RE: BLD2021-04620

**RE: Capitol Park Deck, 1411 Griswold St., Detroit, MI Coffee Shop Reroof Project**

**RE: BLD2021-04620**

## Symbol / Note Key

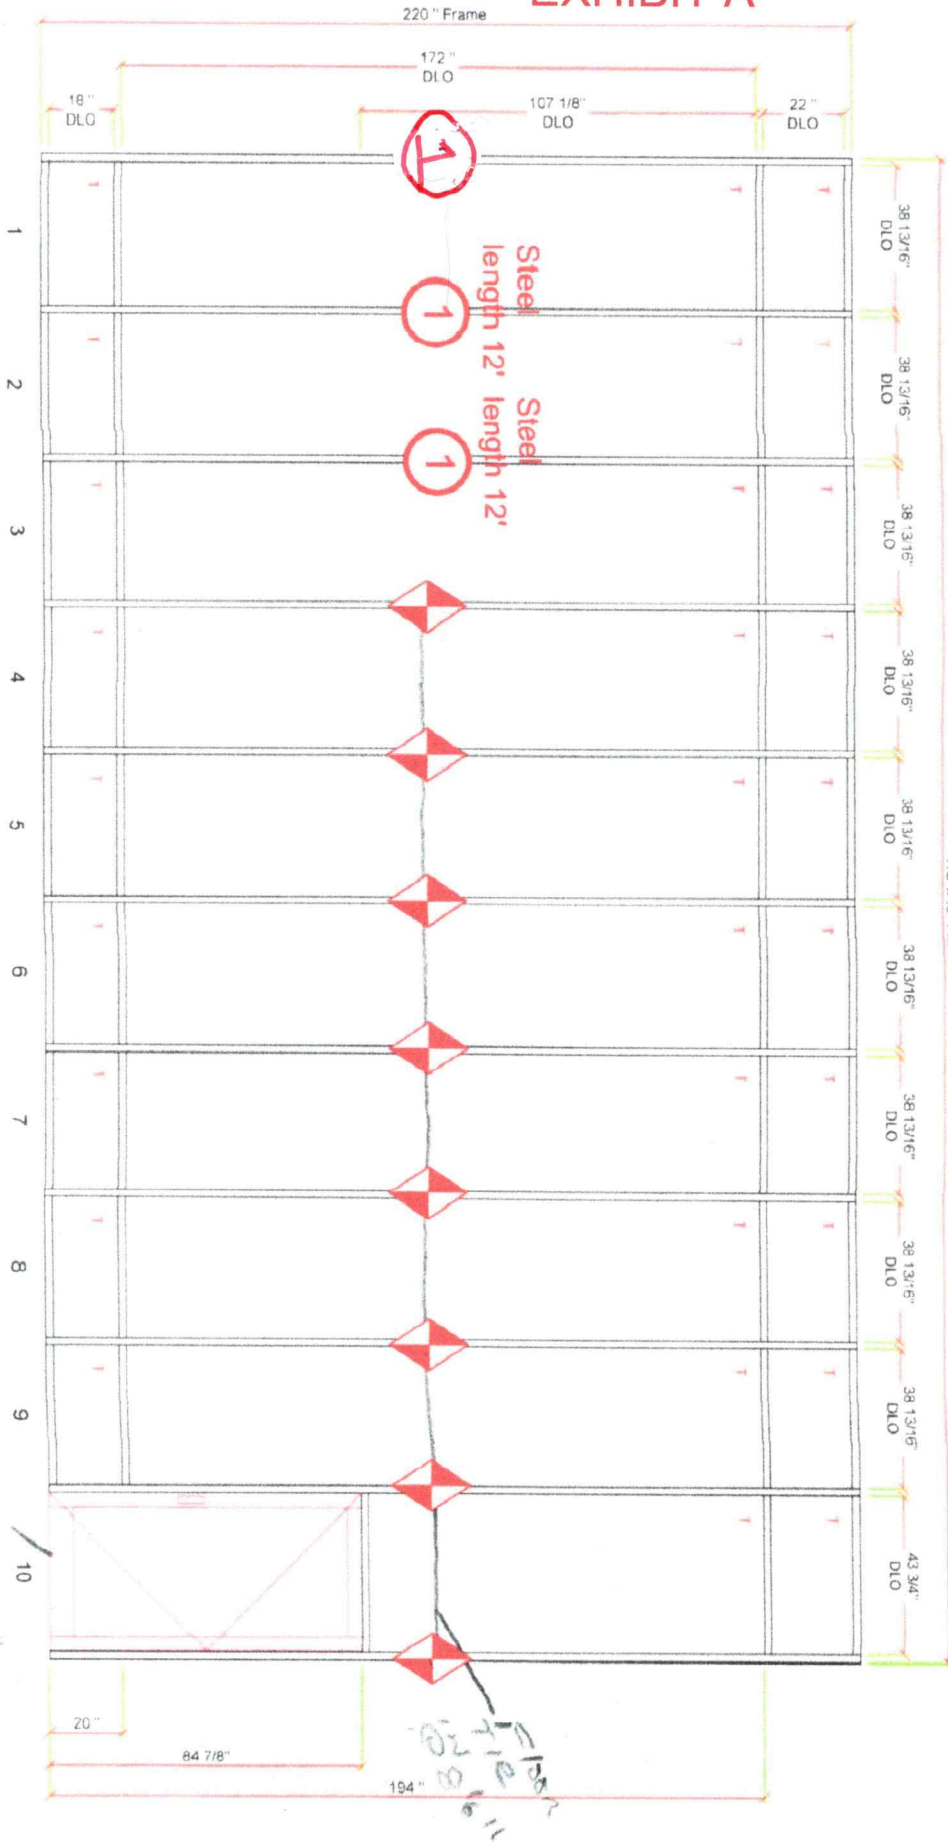
**WIND LOAD CRITERIA:**  
Wind Speed: 115 mph  
Risk Category: II  
Exposure: B  
Building Height: 25' - 0"  
Corner WL: 16.3 psf  
Interior Vestibule WL: 10 psf  
Interior WL: 5 psf

**DEFLECTION CRITERIA:**  
LATERAL DEFLECTION:  
L1/175 for spans less than 13' - 6"  
L/240 + 1/4" for spans greater than 13' - 6"  
LATERAL CANTILEVER DEFLECTION:  
2L/175  
DEFLECTION PARALLEL TO GLAZING PLANE:  
1/8" Maximum

- 1) Wind load conditions assumed based on general project location. If actual wind pressure is greater than the assumed then noted systems will have to be re-evaluated. Wind load calculations in accordance with ASCE 7-10. Building height assumed to be 25'-0".
- 2) Wind load taken from previous review dated 4/9/2020

# EXHIBIT A

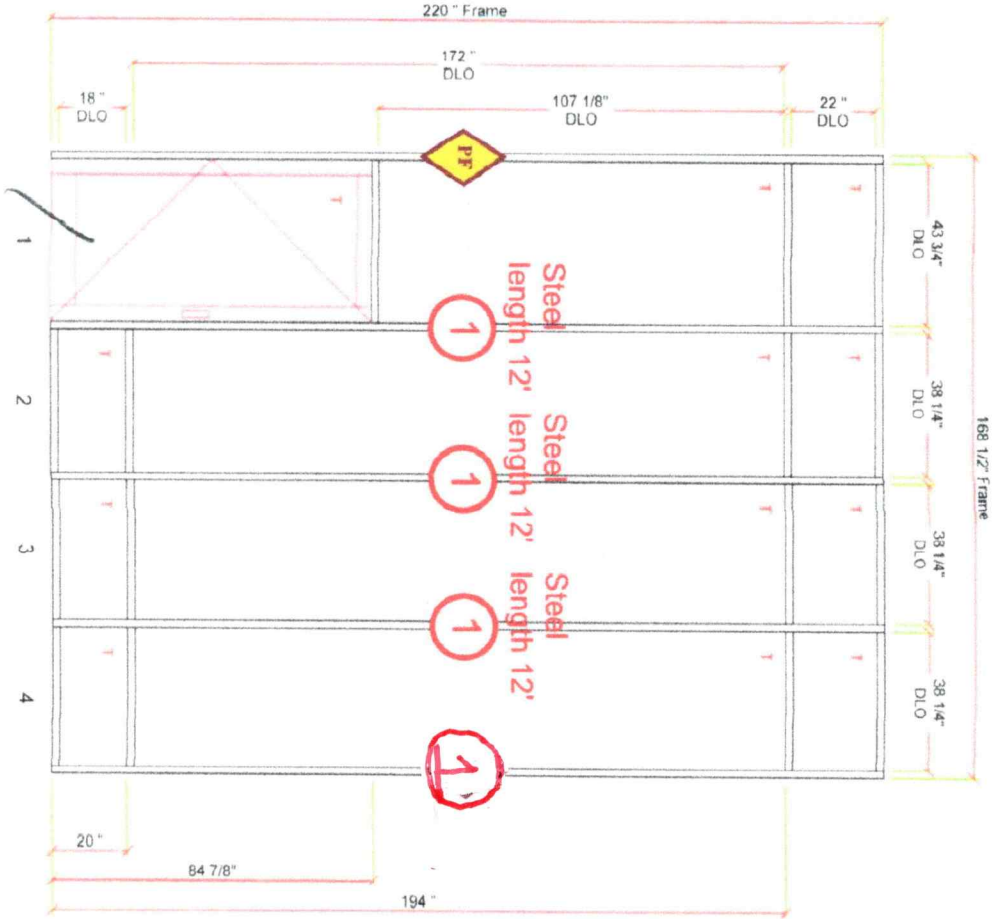
**E1199 OK as noted  
Use F&T anchors**
